EAST COUNTY SUBSTATION PROJECT MINOR PROJECT REFINEMENT REQUEST FORM

Date Submitted:	04-03-14			Request #:		13	
Date Approval Required:	04-11-14			Landowner:		[This information has been redacted due to its confidential nature.]	
APN:	[This info	ormation has been	redacted	due to its confi	ident	tial nature.]	
Refinement from (ch	eck all th	at apply):					
☐ Mitigation Measure	e	□ APM	I			☐ Drawing	☐ Other
Identify source (miti	gation me	asure, project de	scription	, etc.):			
Environmental Impac (Project) describe and Gorge Road and Tule Transmission Line we approved by the Calif request describes shift SP-62, SP-90, SP-91,	Page B-23, Page B-24, and Figures B-2, B-7, and B-8 in Section B. Project Description of the Final Environmental Impact Report/Environmental Impact Statement (EIR/EIS) for the East County Substation Project (Project) describe and depict the alignment of the 138 kilovolt (kV) Overhead Transmission Line between Carrizo Gorge Road and Tule Jim Lane. In addition, changes due to the final design of the 138 kV Overhead Transmission Line were discussed and evaluated in Minor Project Refinement (MPR) request #6, which was approved by the California Public Utilities Comm

ATTACHMENT B: REFINEMENT AREA OVERVIEW MAP

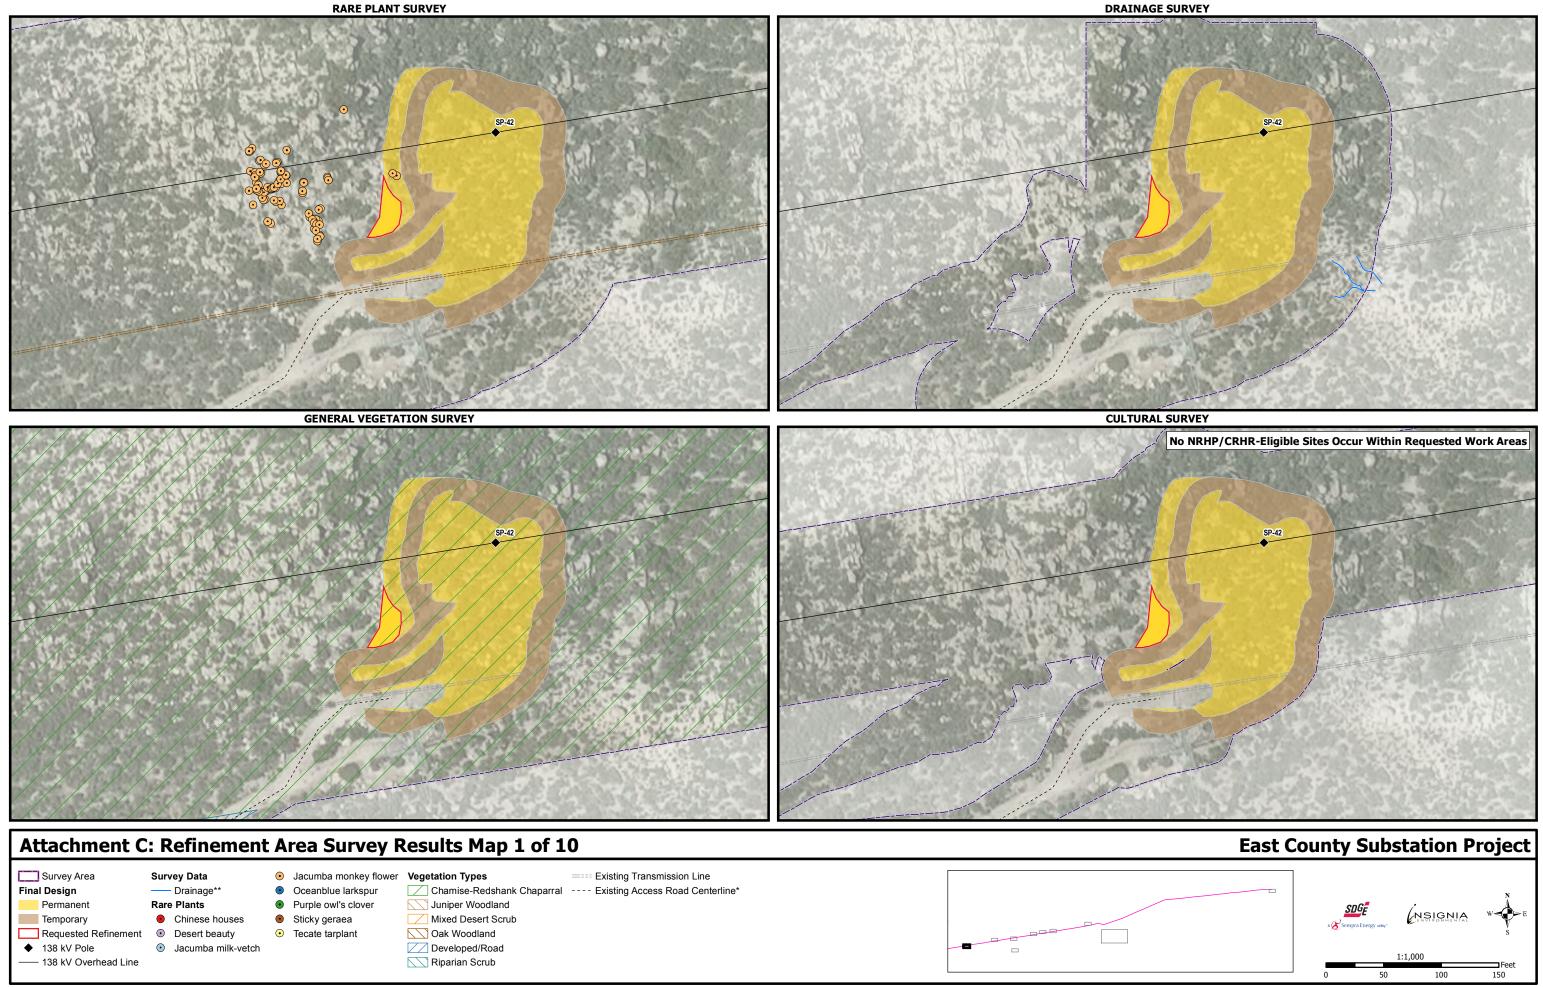
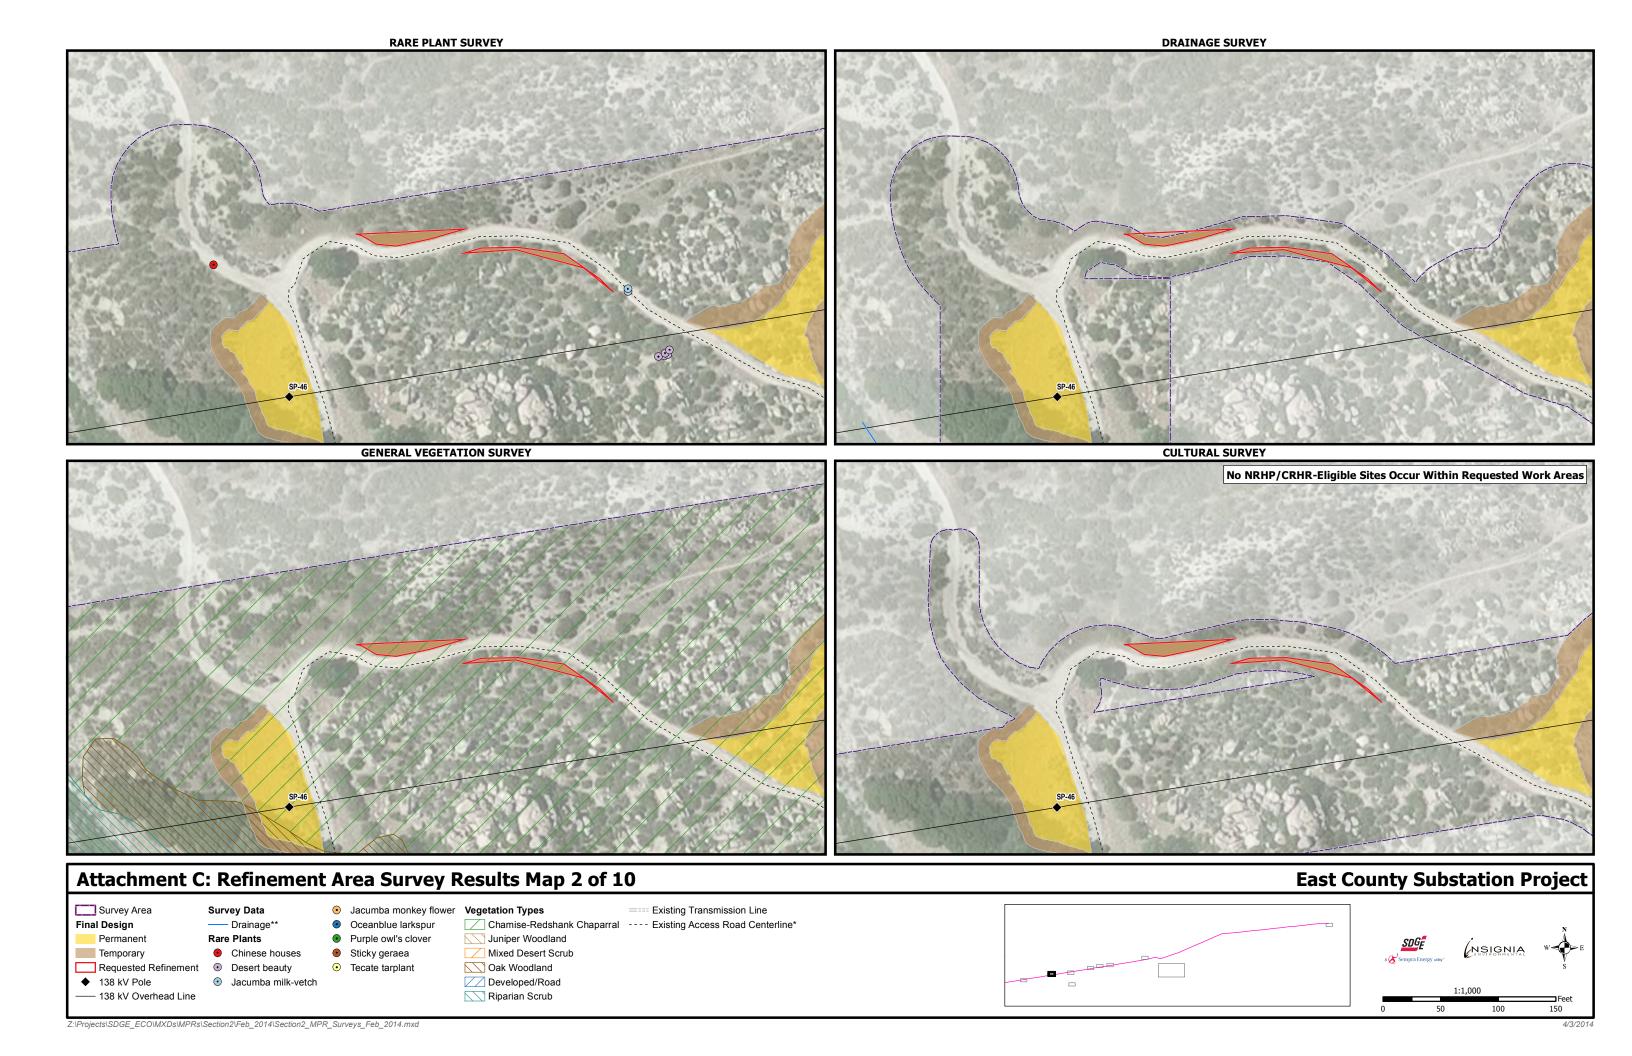
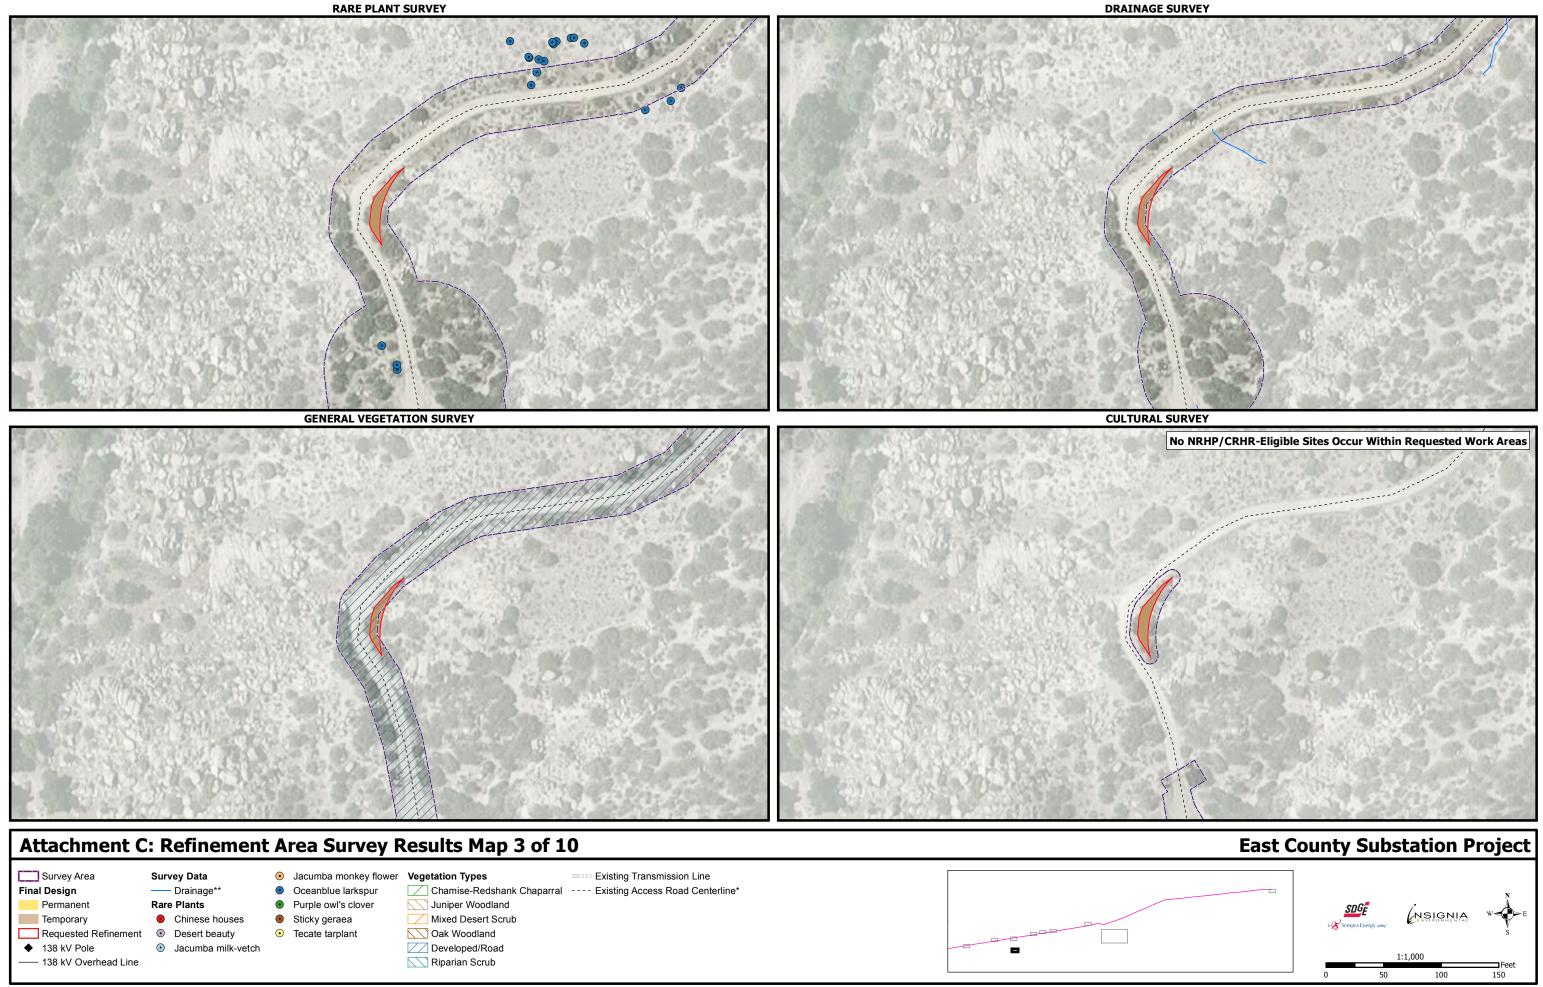
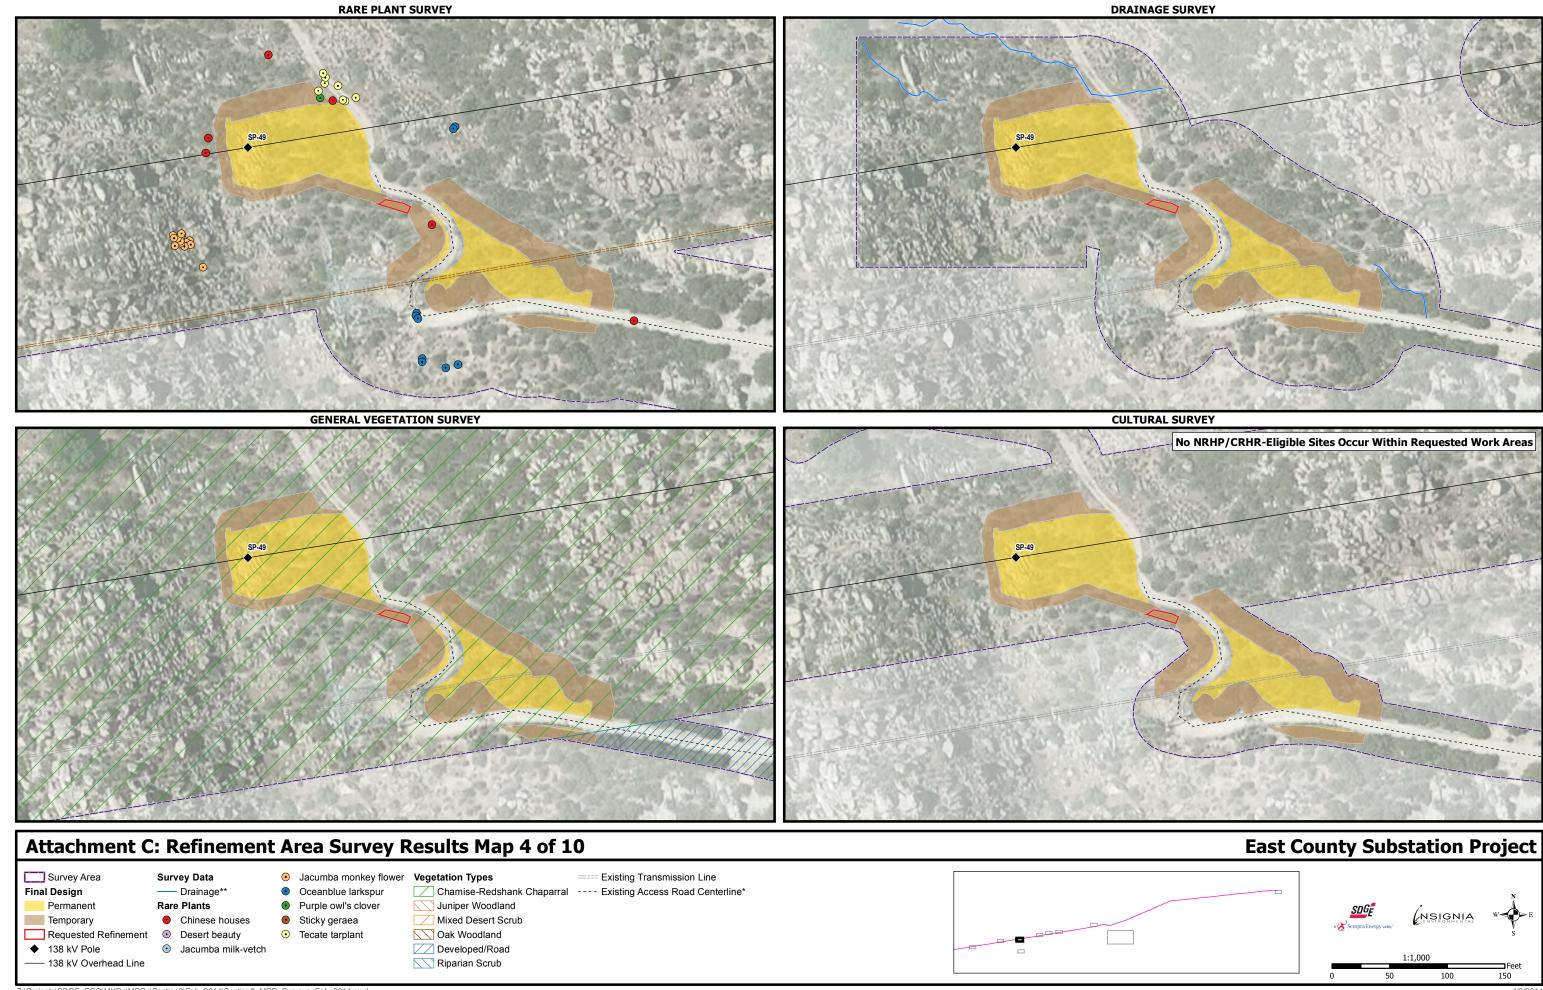
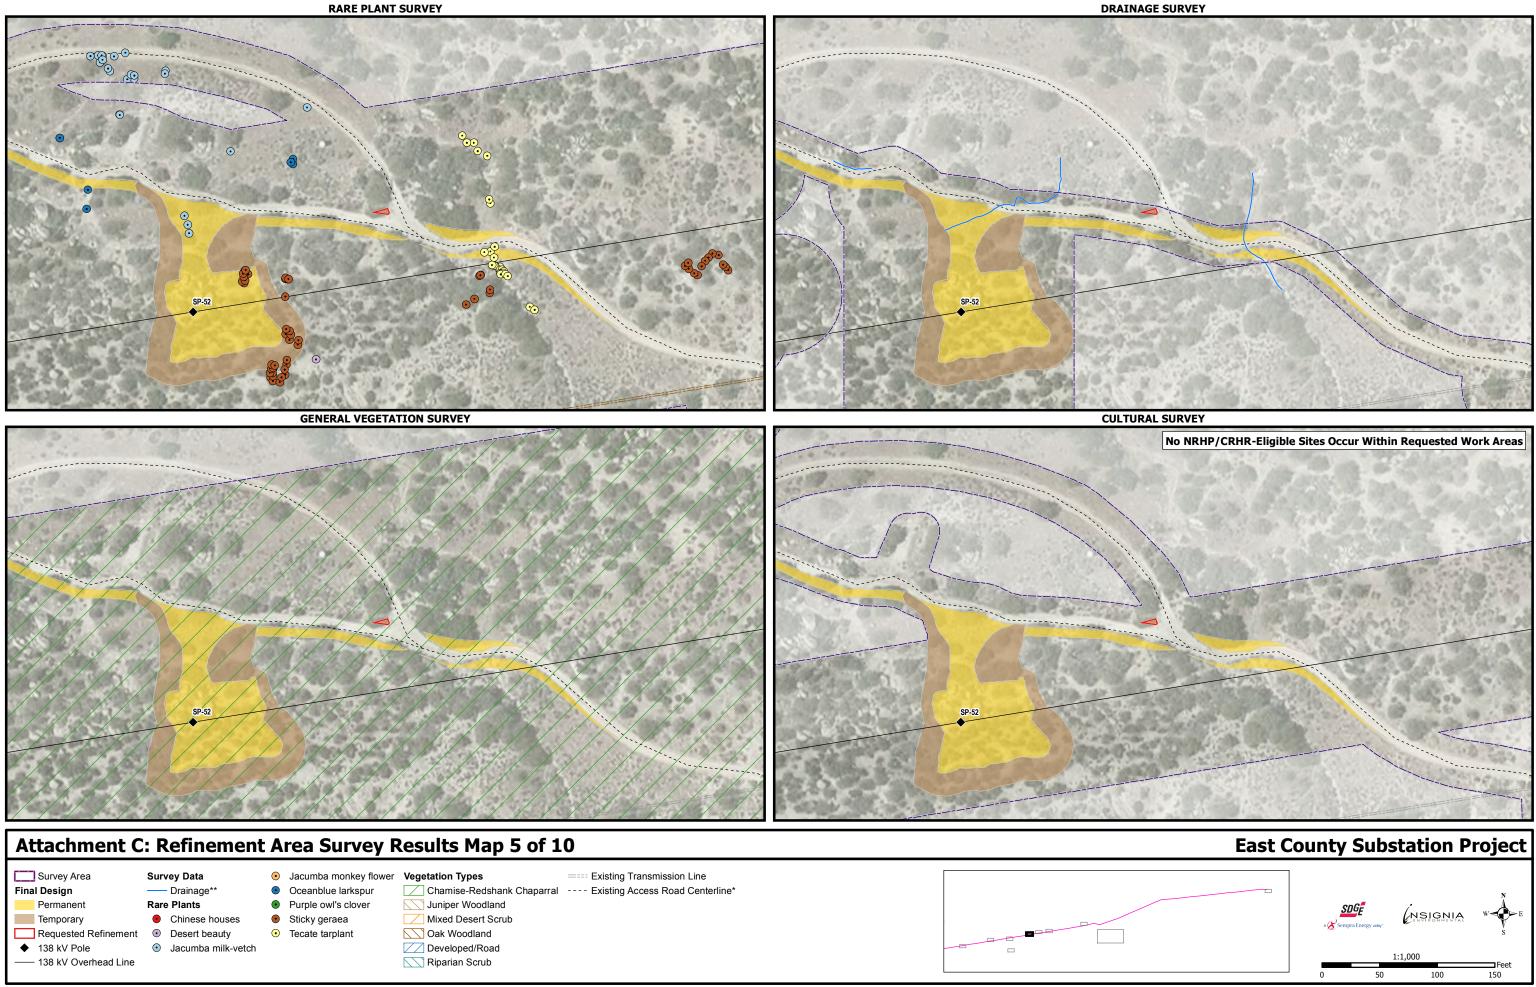
The minor refinements described in this MPR request are required to accommodate the equipment needed to construct the transmission line and to prevent potential safety hazards and erosion control problems from existing site conditions. The refinements will result in a total increase of the Project's temporary impacts by approximately 0.187 acre and permanent impacts by approximately 0.076 acre. The specific shifts at each refinement site are described in the following paragraphs.

Temporary workspace will be increased by approximately 0.003 acre at SP-49 to join the adjacent work areas, allowing better access between the graded areas. Approximately 0.024 acre of temporary workspace and approximately 0.001 acre of permanent grading will be added at AR-6.2 and AR-10, respectively, to mow the brush along the side of the road in order to provide adequate space for construction equipment. In addition, temporary impacts will be increased by approximately 0.009 acre at AR-7.2 to mow the brush in order to provide an adequate turning radius for construction equipment.

Additional temporary workspace along AR-21/22 is required to smooth the surface of the existing dirt road as the road's current uneven surface provides unsafe conditions for construction equipment to pass through. This refinement will result in an increase of approximately 0.191 acre of temporary impacts due to the access road modifications. Also, an additional temporary workspace of approximately 0.004 acre at G-10E is required to remove two existing steel posts in order to allow sufficient access by construction equipment.

The refinement at SP-42 will result in an increase of approximately 0.016 acre of permanent impacts to remove or secure a boulder located outside of the work limits that has the potential to roll into the work site and cause damage to the existing Southwest Powerlink tower, construction equipment, and/or cause injury to construction personnel.

The refinement at SP-62 is required to raise the ground elevation in order to promote drainage in the area between the graded pad slope and existing slope, as the existing site conditions cause runoff water to pond and have the potential to cause erosion if not elevated. The required work to raise the ground elevation of the area will convert approximately 0.011 acre of approved temporary impacts to permanent impacts.

In addition to a conversion in approximately 0.055 acre of approved temporary impacts to permanent impacts, approximately 0.015 acre of permanent impacts and 0.01 acre of temporary impacts will be added at SP-91. These changes in the SP-91 workspace are required to remove an undocumented stockpile of non-native sand and/or fill that has been left at the location and to grade the area to pre-existing condition. The stockpile at SP-91 currently does not meet geotechnical compaction requirements and is not natural.

At SP-90, the temporary workspace was slightly increased by converting approximately 0.006 acre of approved

permanent grading to temporary impacts. In addition, the maintenance pad at SP-90 was slightly increased by converting approximately 0.011 acre of approved temporary workspace to permanent impacts. These shifts were required to more effectively manage drainage and control erosion at the site.

An overall addition in approximately 0.015 acre of temporary impacts and reduction of approximately 0.026 acre of permanent impacts at SP-55 are required to re-route the access road to avoid an environmentally sensitive area discovered during rough-grading.
